VILLAGE OF GERMANTOWN
N112 W17001 MEQUON ROAD
GERMANTOWN, WI 53022

MEETING: REGULAR MEETING OF THE VILLAGE BOARD

DATE AND TIME: MONDAY, March 18, 2019 7:00 p.m.

CONDITIONAL USE PERMIT (CUP) APPLICATION & SITE PLAN REVIEW

SHEET TITLE: SITE FENCING EXHIBIT

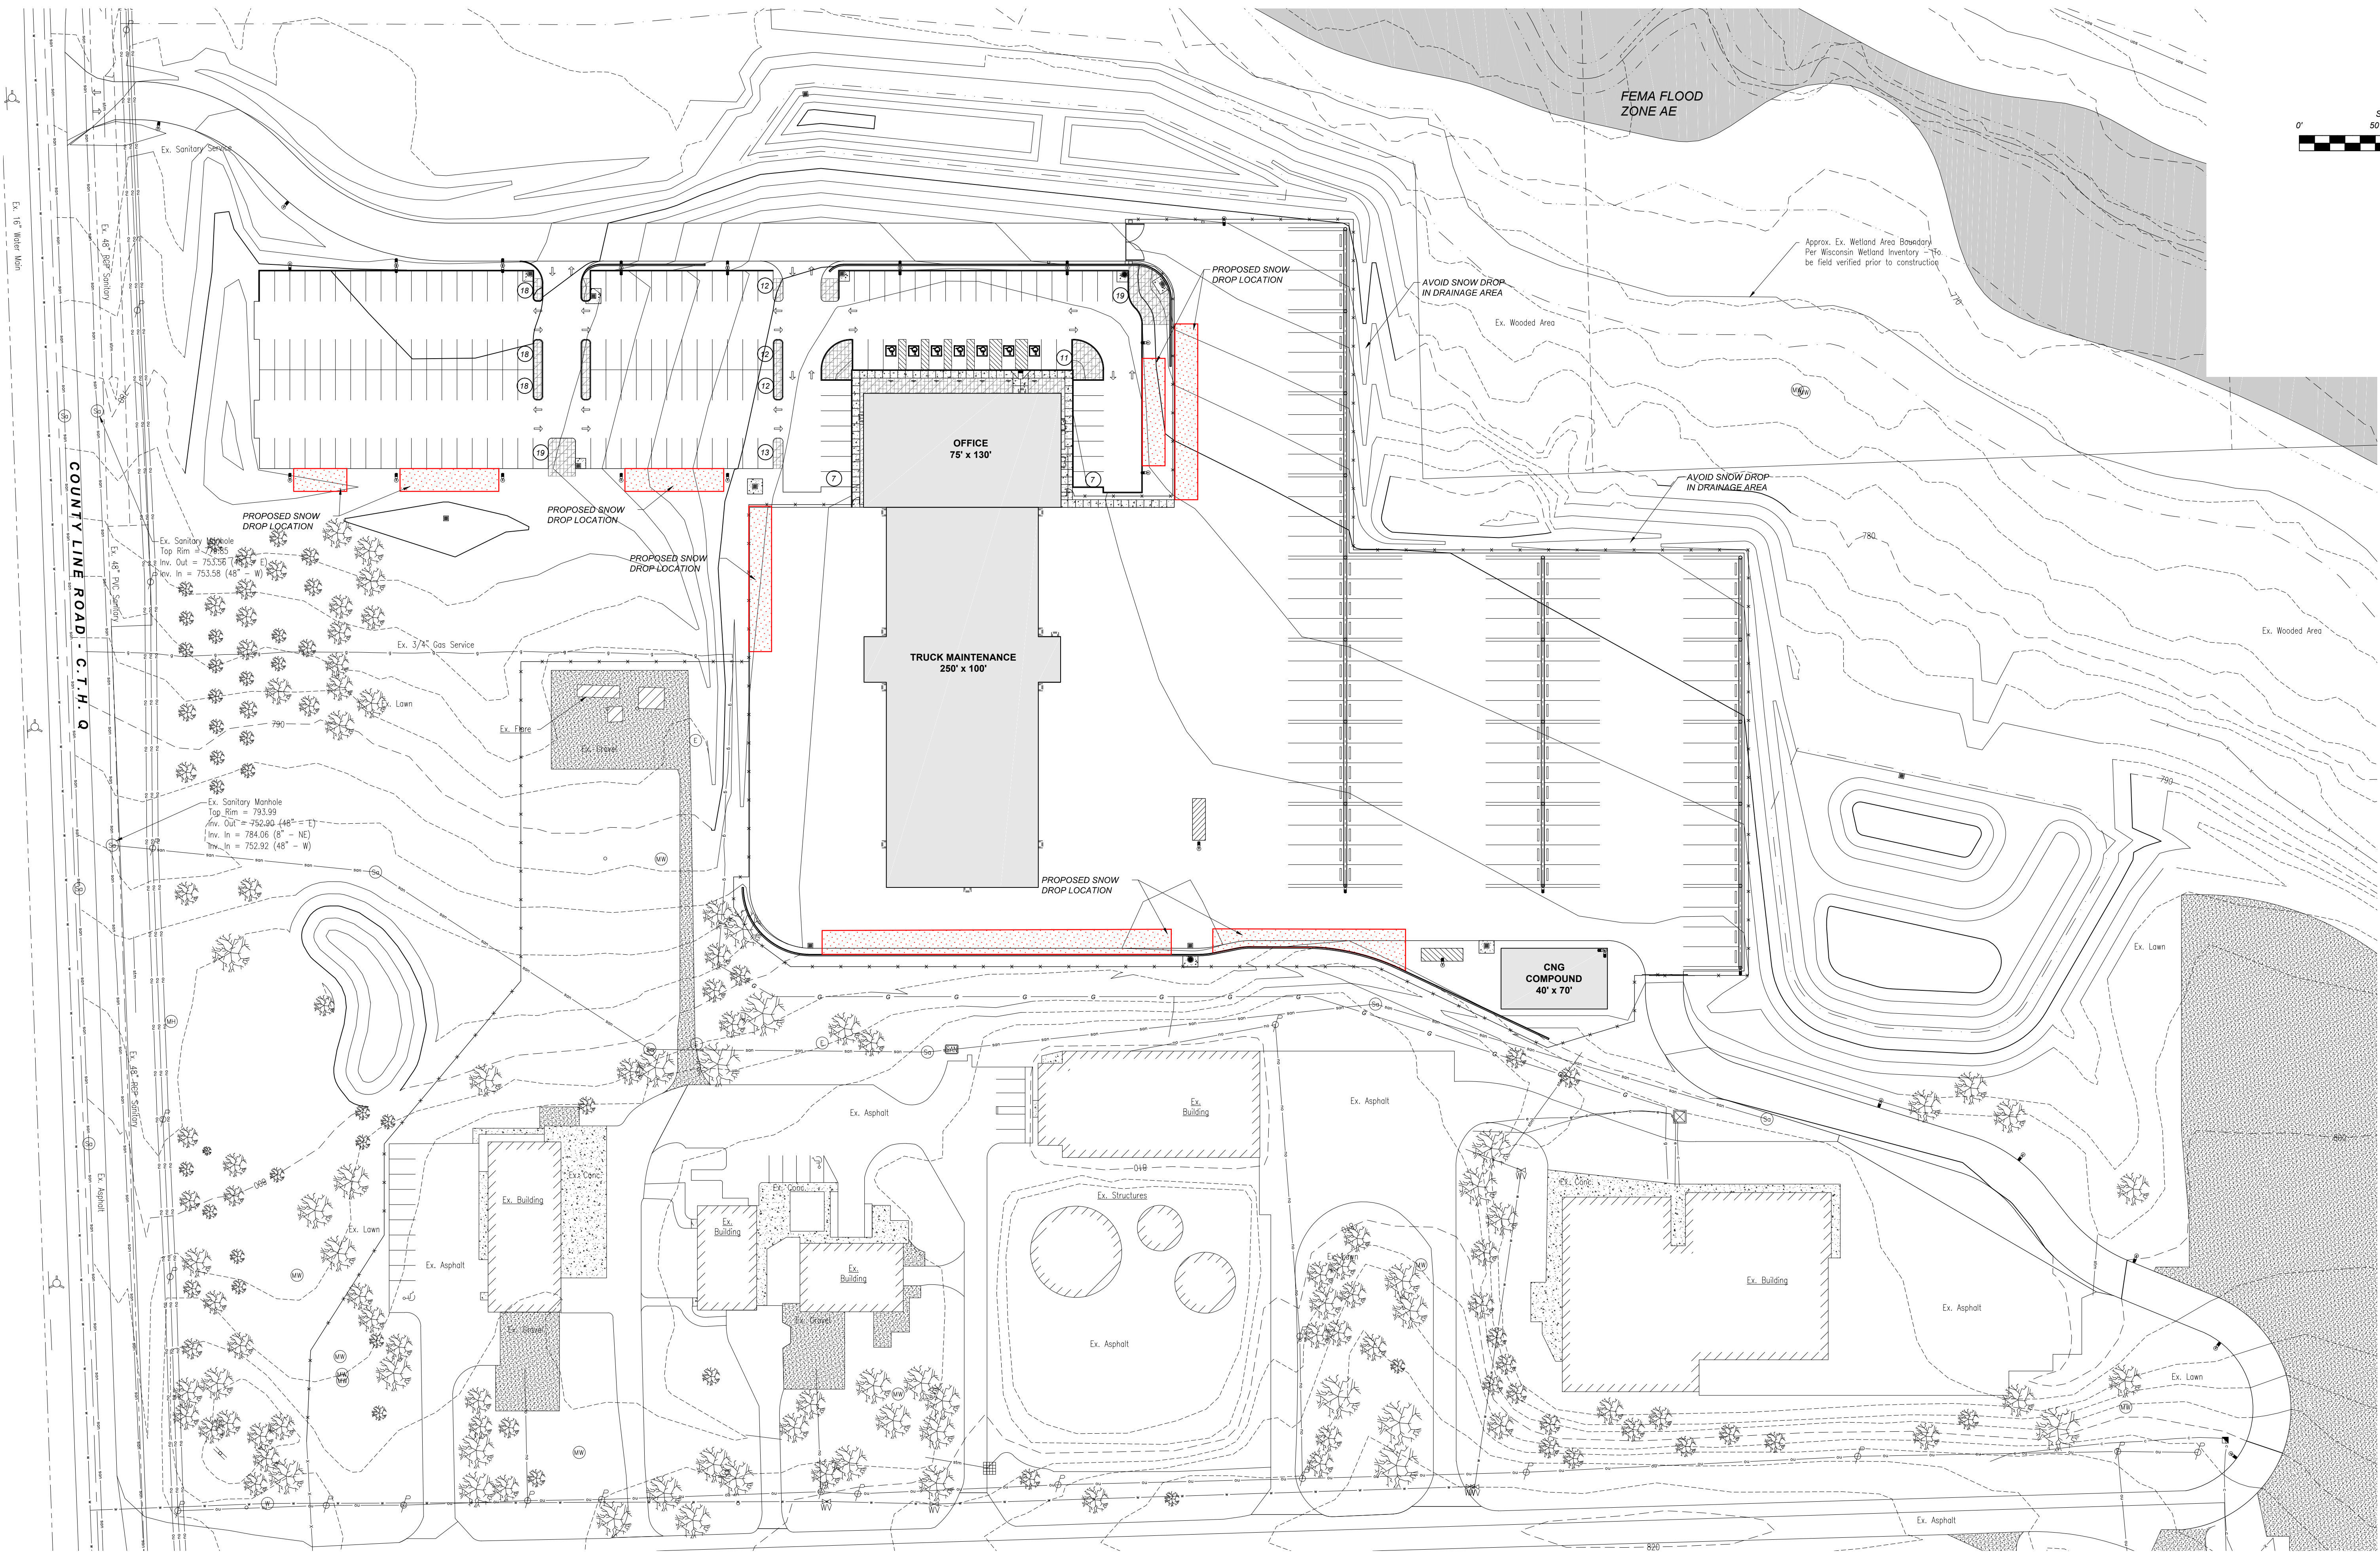
Existing chain link fencing around the existing Port-O-Let operation will be removed and replaced with new 6' chain link fencing around the maintenance building and parking area for the waste removal/recycling trucks. Controlled gates will be installed at two points of entry/exit to the north parking area and maintenance building (Sheet X1.1).

Response: A fencing exhibit has been added to the plan set, sheet X1.1 depicting the fencing to be removed and the location of the new fencing. A detail for the proposed fence has also been added to this sheet.

Response: A fencing exhibit has been added to the plan set, sheet X1.1 depicting the fencing to be removed and the location of the new fencing with tie-in locations noted along the frontage to the east side of the property.

SHEET NO:
A1.0

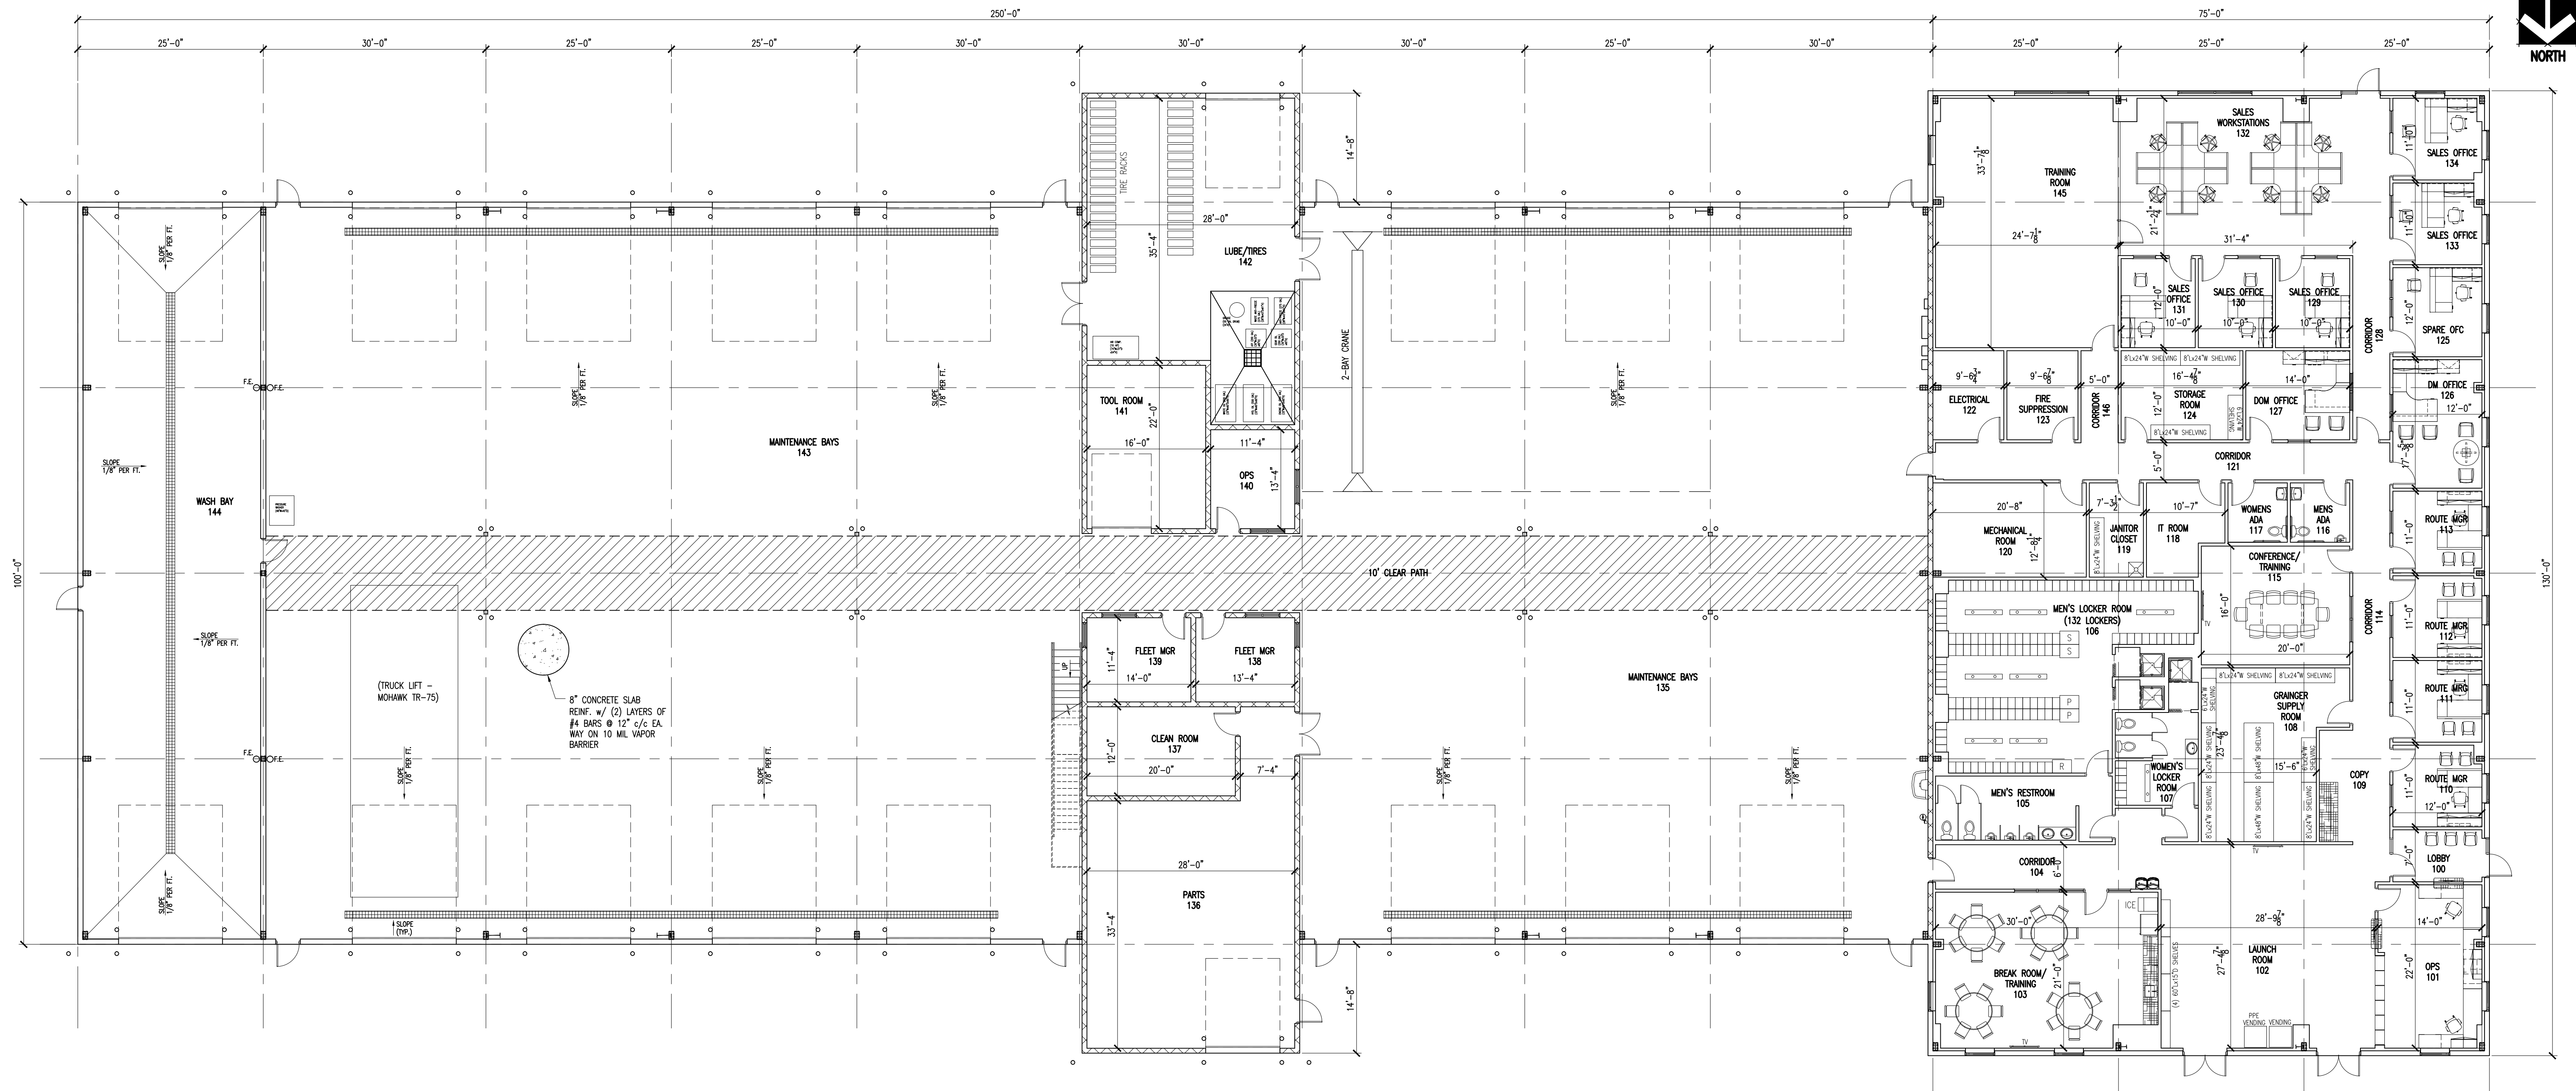
- s. On sheet A1.0 the women's locker room is to have an additional partition or doorway between the entrance and the locker room area.

h. On sheet A1.0 the women's locker room is to have an additional partition or doorway between the entrance and the locker room area.

Response: An additional door has been added to the floor plan. See sheet A1.1.

TYPICAL CNG TRUSS

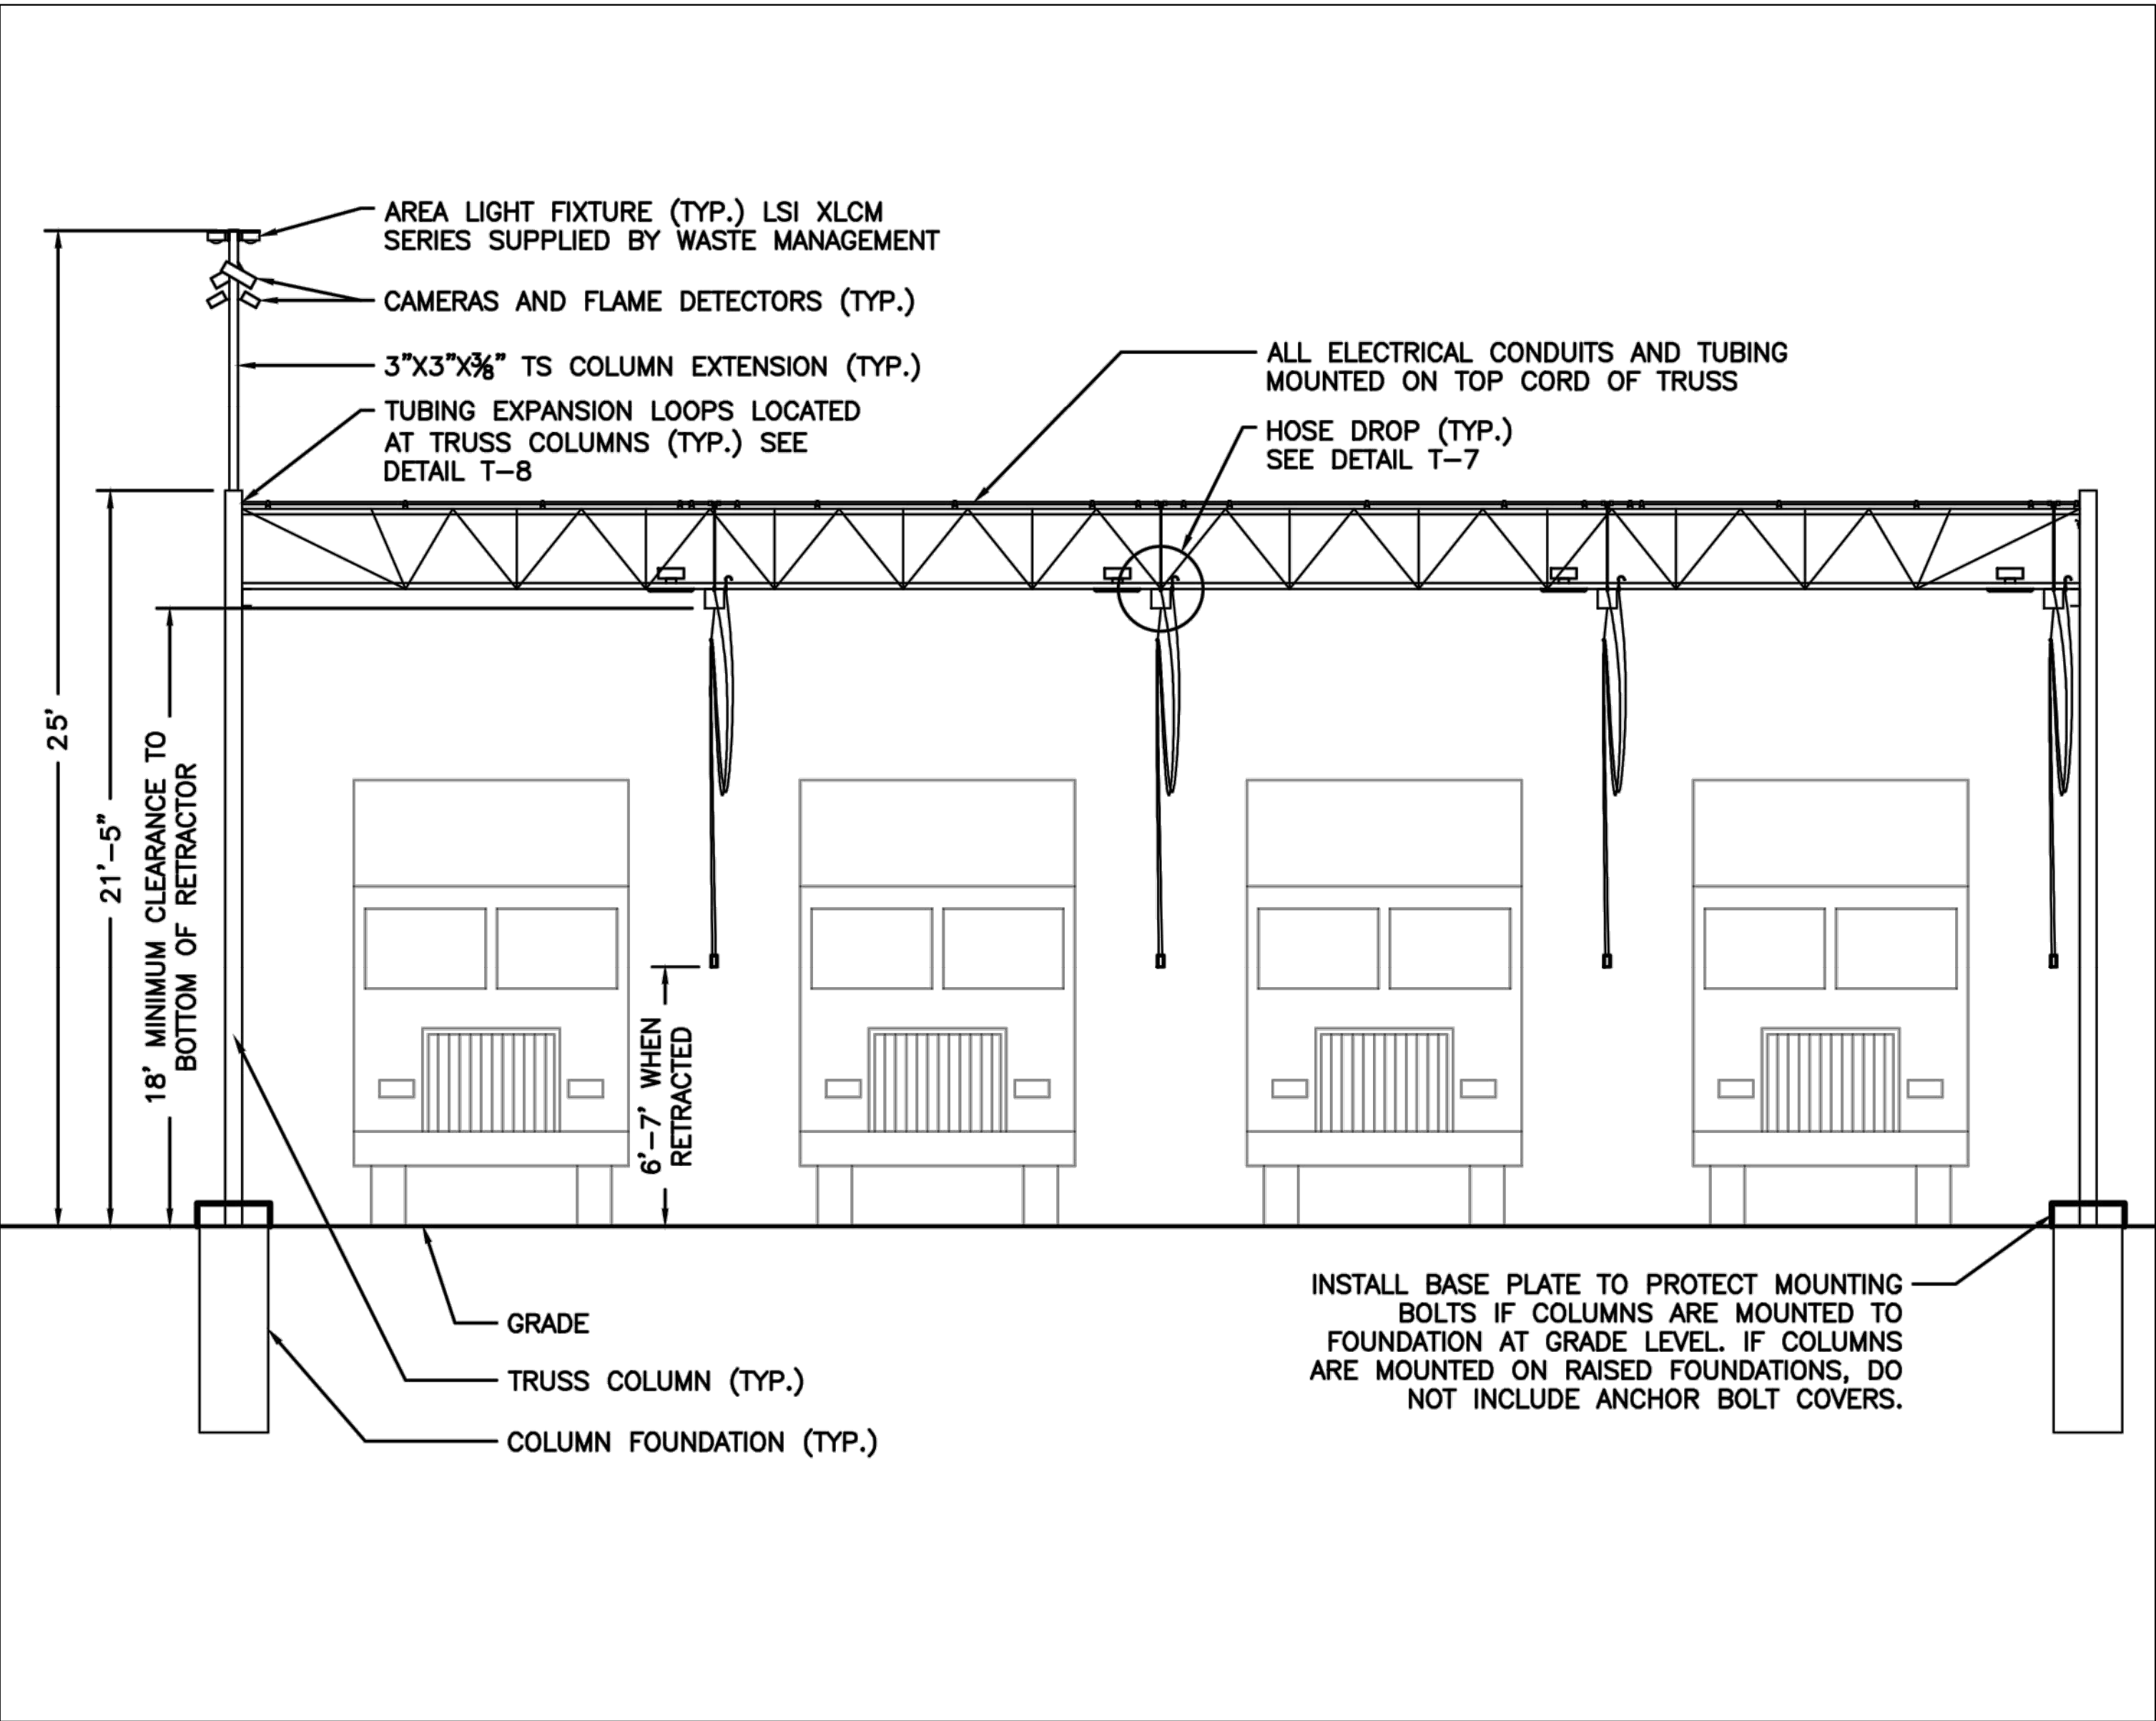
Apart from the building elevations shown on Sheet A2.0, there is no detail showing how the over-head CNG refueling stations work or appear. Are there underground or overhead pipes to be installed leading from the CNG compound to the individual parking stalls? If overhead, what structures are proposed? What do they look like? Similarly, the lighting plan shows quite a number of lighting fixtures (68) to be surface-mounted at the end of the parking stalls. Surface-mounted to what?

Response: An elevation detail for the CNG truss fueling system has been added to the plan set on sheet A1.2. This detail calls out the elevations and locations of lighting and overhead pipes. All pipes feeding to the trusses from the compound will be below ground.
